Access Compliance Report

Public Rights-of-Way

Intersection ID: N/A	Main Street: CENTER PARK DR	Cross Street: BEAM RD	Location: SE
ADA ID: 09B1FB62BF4E	Ramp Type: PerpDiag	Initial Pass/Fail: Fail	Overall Compliance: No
		Severity Score: 30

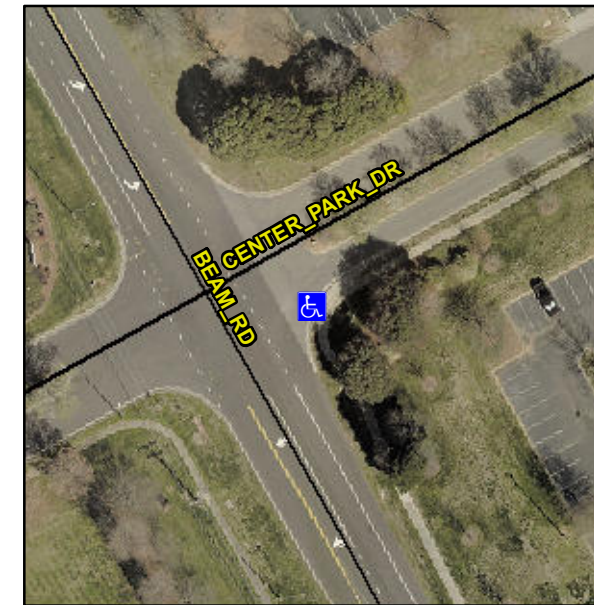
Not Found, R304.5.1, R304.5.3

Compliance	Description	Data	Compliance	Description	Data
N/A	Ramp Length (in)	108.0	Yes	Ramp Slope (%)	5.6
No	Ramp Width (in)	35.0	No	Ramp XSlope (%)	6.1
N/A	Flare Type LT	N/A	N/A	Flare Type RT	N/A
N/A	Flare Slope LT (%)	N/A	N/A	Flare Slope RT (%)	N/A
N/A	Flare Traversable LT?	N/A	N/A	Flare Traversable RT?	N/A
N/A	Landing Length (in)	N/A	N/A	DWS Provided?	N/A
N/A	Landing Width (in)	N/A	N/A	DWS Contrast?	N/A
N/A	Landing Slope (%)	N/A	N/A	DWS Length (in)	N/A
N/A	Landing X Slope (%)	N/A	N/A	DWS Full Width?	N/A
N/A	Landing Curb? (Y/N)	N/A	N/A	DWS Offset (in)	N/A
N/A	Shared Landing?	N/A			
N/A	Gutter Ponding?	N/A	N/A	Gutter Slope (%)	N/A
N/A	Gutter Lip Ht (in)	N/A	N/A	Gutter X Slope (%)	N/A
N/A	Painted X Walk1?	No	N/A	Painted X Walk2?	No
	X Walk 1 Direction	To N		X Walk 2 Direction	To W
N/A	X Walk 1 Width (in)	N/A	N/A	X Walk 2 Width (in)	N/A
	X Walk 1 Slope (%)	1.4		X Walk 2 Slope (%)	5.3
	X Walk 1 X Slope (%)	6.4		X Walk 2 X Slope (%)	1.9

Remove & Replace Curb Ramp With Two New Directional Ramps or Equivalent.
